HISTORIC AND DESIGN REVIEW COMMISSION

HDRC CASE NO: 2019-089
ADDRESS: 125 E CAROLINA ST
LEGAL DESCRIPTION: NCB 3009 BLK 7 LOT W 48 FT OF 16
ZONING: RM-4, H
CITY COUNCIL DIST.: 1
DISTRICT: Lavaca Historic District
APPLICANT: Eleanor Cordova
OWNER: Eleanor Cordova
TYPE OF WORK: Front porch modifications
APPLICATION RECEIVED: February 20, 2019
60-DAY REVIEW: April 21, 2019

The applicant is requesting a Certificate of Appropriateness for approval to modify the existing front porch by:

1. Adding wood over the concrete slab.
2. Installing a wood railing.

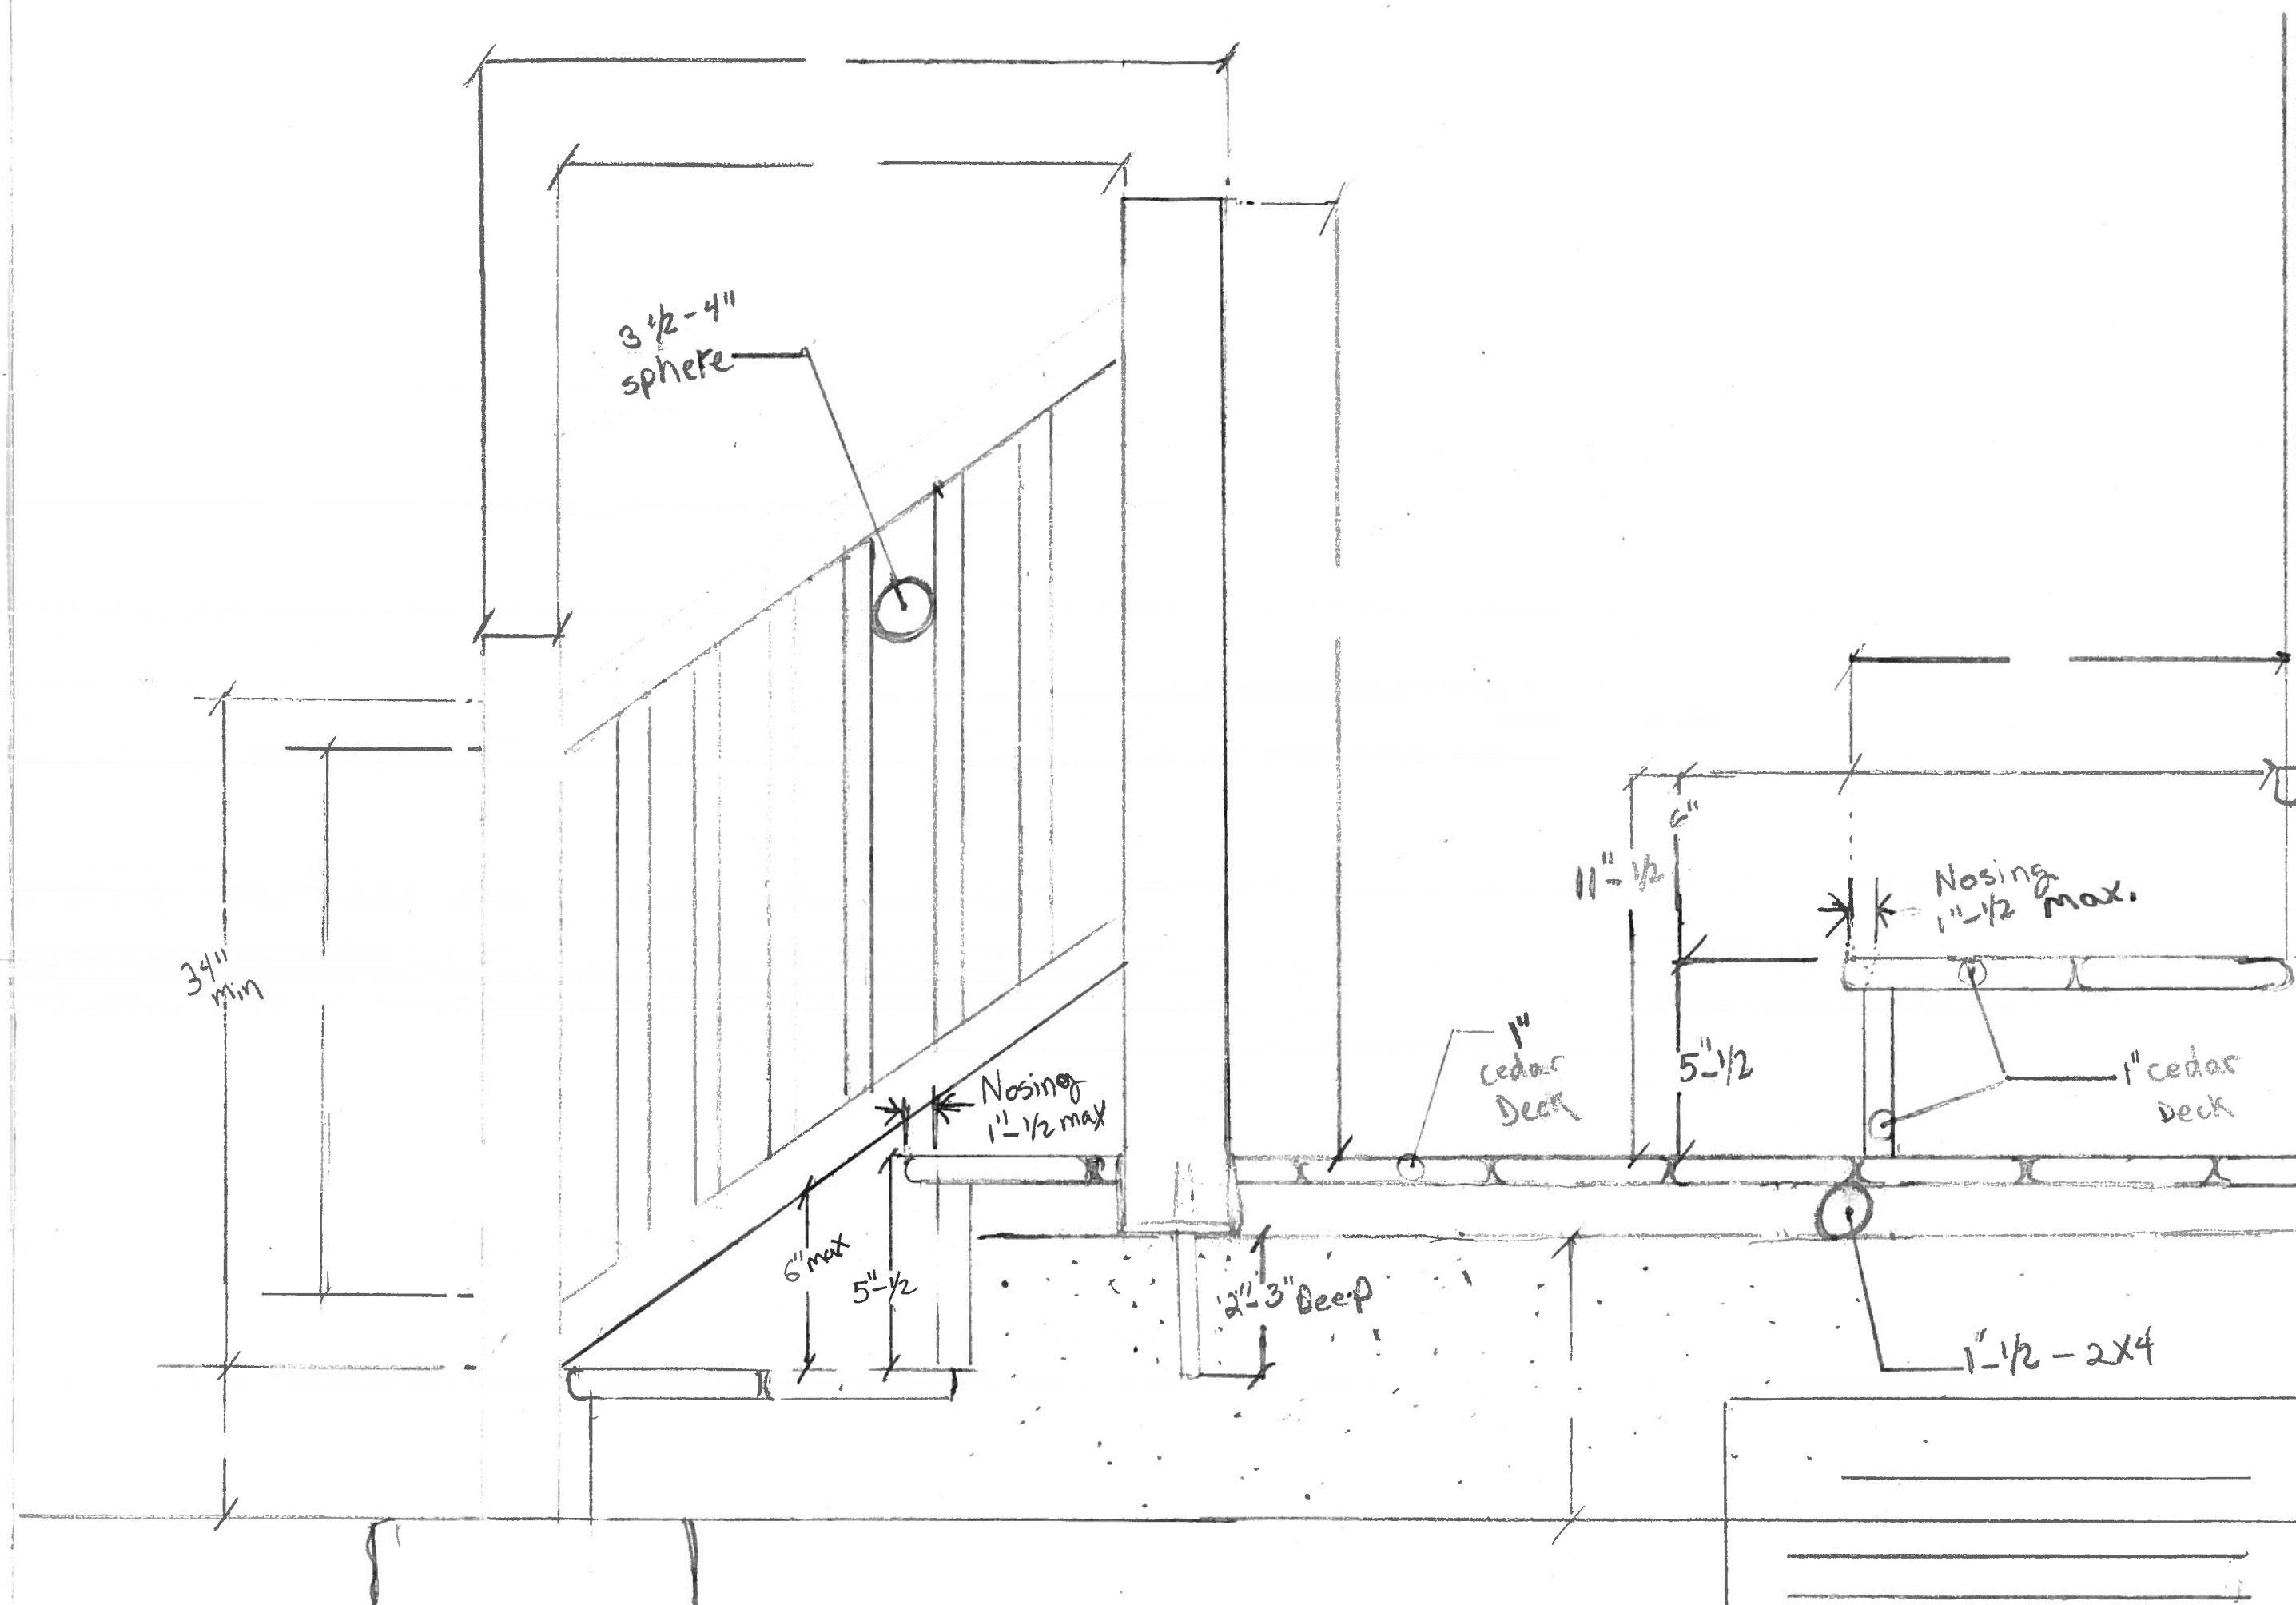
- b. **FRONT PORCH SLAB MODIFICATION** – The applicant has proposed to modify the existing concrete front porch slab by installing a new wooden deck on top of it. According to the Historic Design Guidelines, original concrete porch floors should be preserved. The existing concrete front porch slab will remain intact, and the proposed modification to it is reversible. Therefore, staff finds the installation of the wood decking acceptable.
- c. **INSTALLATION OF HANDRAIL** – The applicant has proposed to enclose the front porch, for safety reasons, with a new wood handrail. No modifications will be made to the front façade as part of this work. Staff finds that the proposed handrail will not detract from the significance of the structure.

Staff recommends approval of the porch modifications based on finding a through c.
